ORIGINATION FORM

Proposed Revisions to a Standard Plans Index
(Please provide all information — Incomplete forms will be returned)

Index Number: 102-600
Sheet Number (s): 5, 6, and 7 of 11
Index Title: General Information for Traffic Control Through Work Zones

3 POST SIGN SUPPORT MOUNTING DETAILS

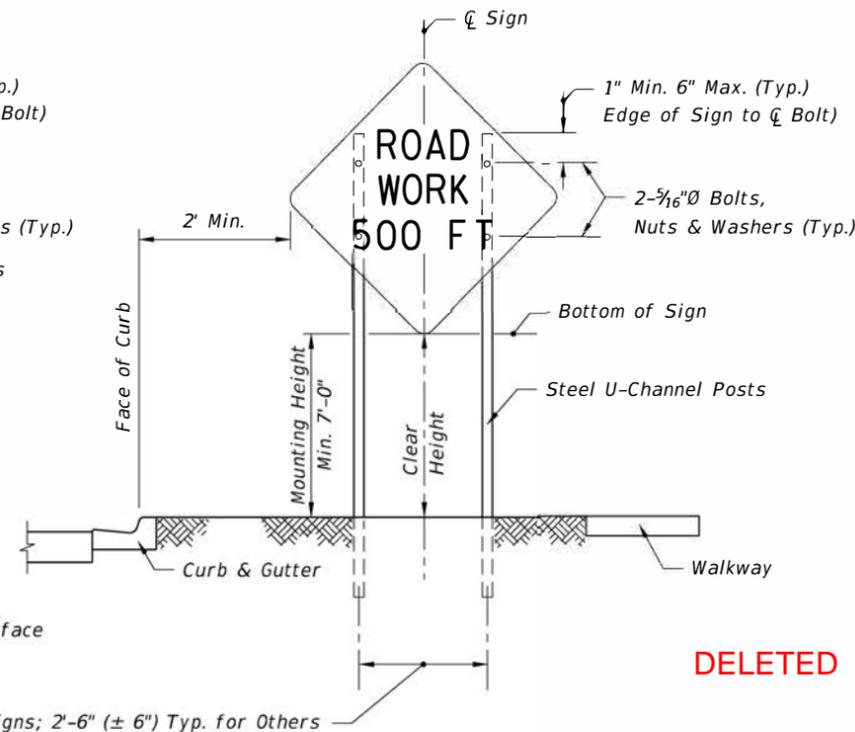
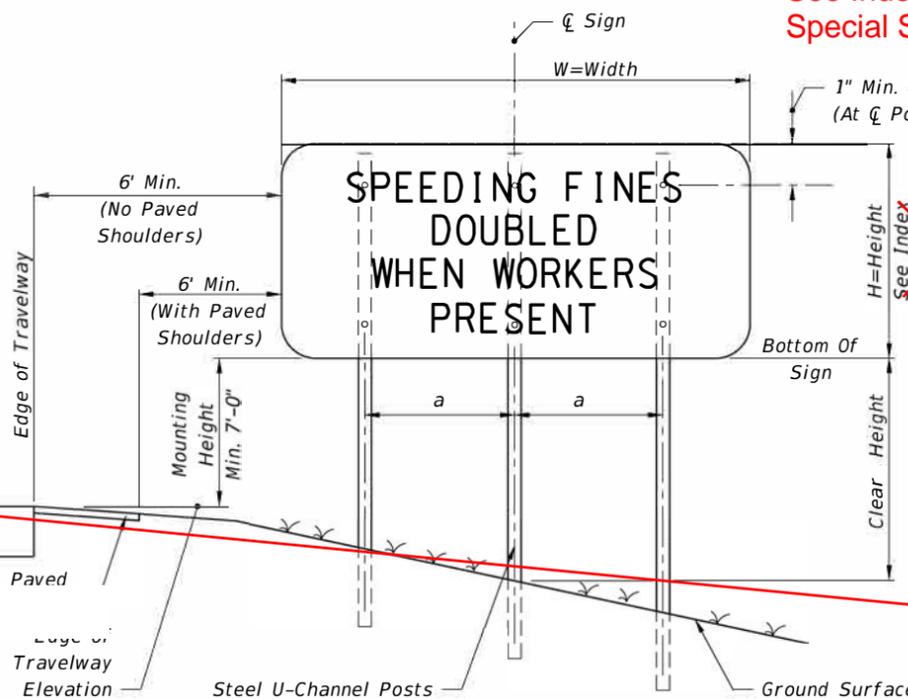
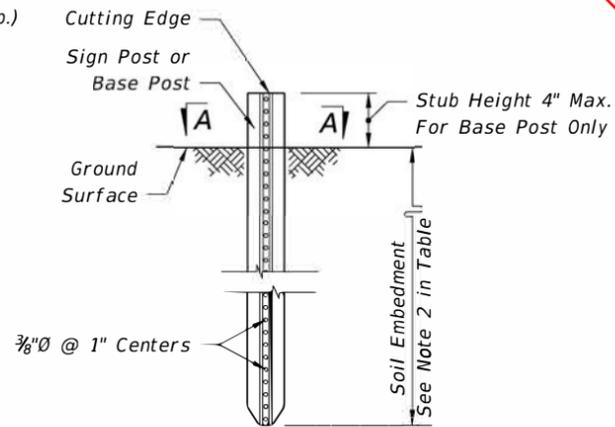
Sheet 5: Changed the Height reference note to "See Index 700-102 for Special Sign Details" and deleted the 60" Width in the 3 POST SUPPOR MOUNTING DETAILS; Moved TEMPORARY SIGN SUPPORT NOTE 9 to TABLE 7, as Note 5; Deleted the 60x64 and the 120x60* Rectangle signs and associated note from TABLE 7; Deleted "(See Note 7)" reference from the Diamond sign in TABLE 7.

Where $W = 48"$: $a = 1' - 4\frac{1}{2}" (\pm 1")$
 ~~$W = 60"$: $a = 1' - 9" (\pm 1")$~~
 $W = 72"$: $a = 2' - 1" (\pm 1")$

Deleted

See Index 700-102 for Special Sign Details

COMMONLY USED WARNING AND REGULATORY SIGNS IN WORK ZONES

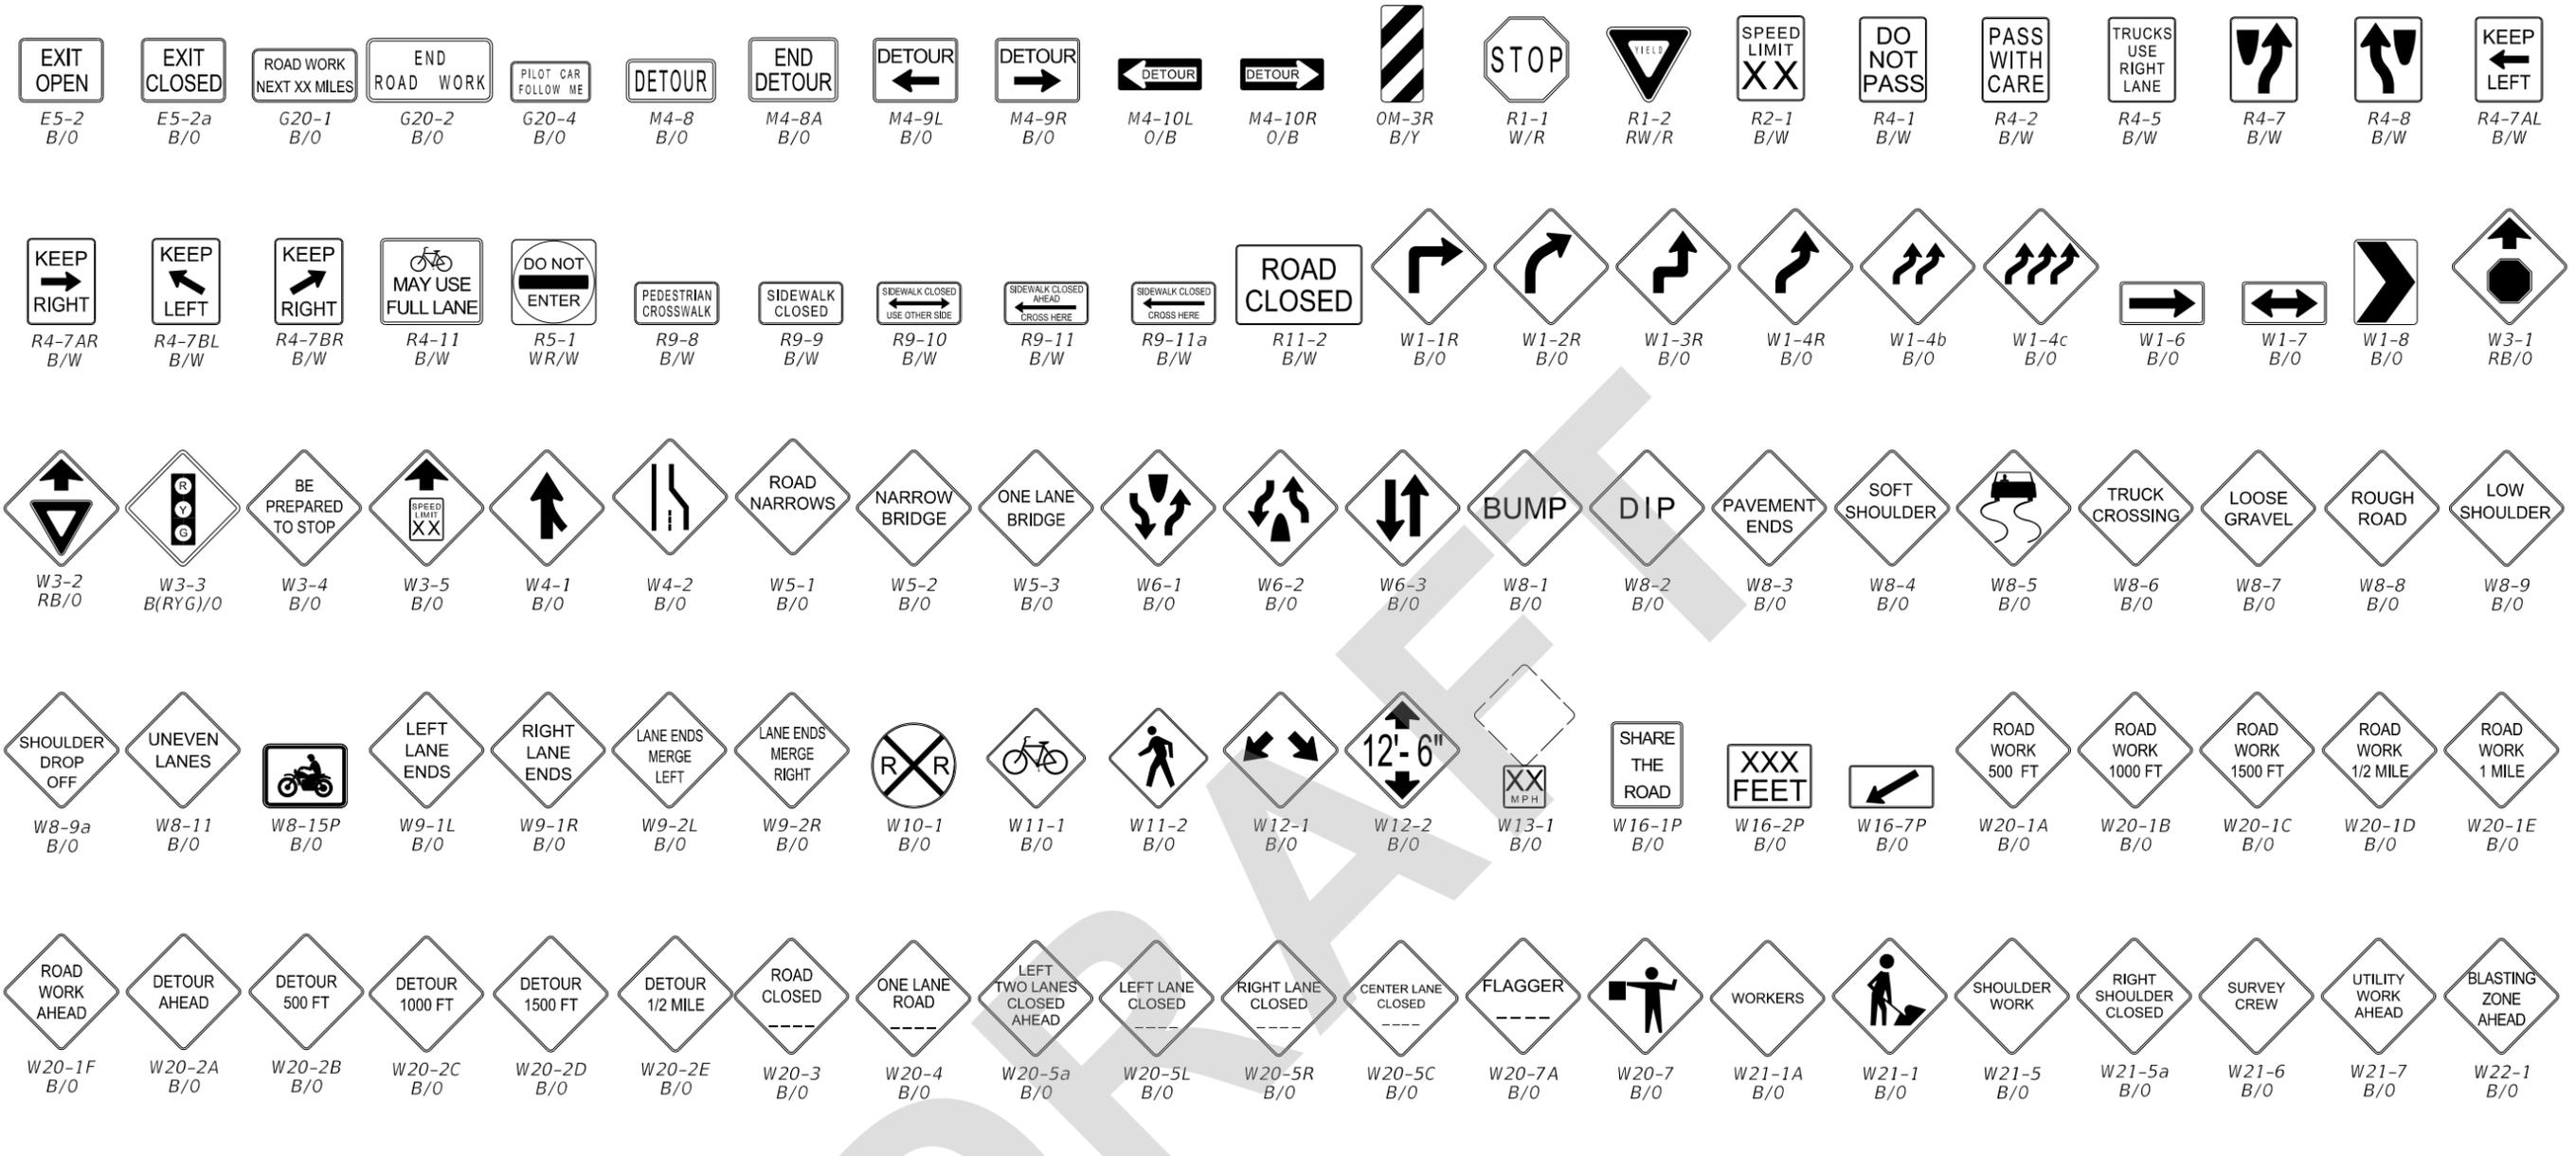
Sheet 6: Rearranged all signs: Added signs: R4-11, W11-1, and W16-1p: Deleted all of the "MOT" signs.

ADDED SIGNS:
 R4-11
 W11-1
 W16-1P

DELETED ALL OF THE MOT SIGNS

SIDE ROAD INTERSECTING THE WORK ZONE

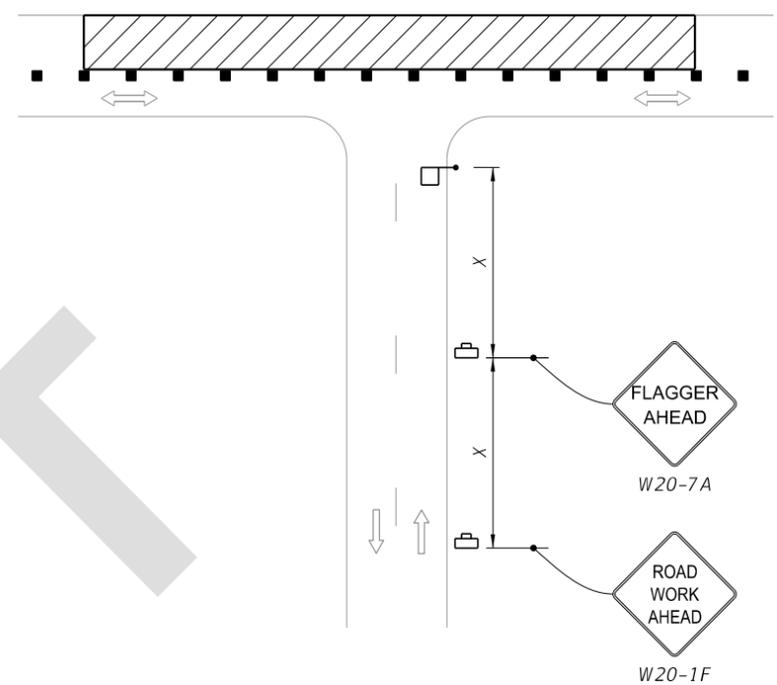
Sheet 7: Added the SIDE ROAD INTERSECTING THE WORK ZONE details form Index 102-606.

**ADDED:
SIDE ROAD INTERSECTING THE WORK ZONE
detail from Index 102-606**
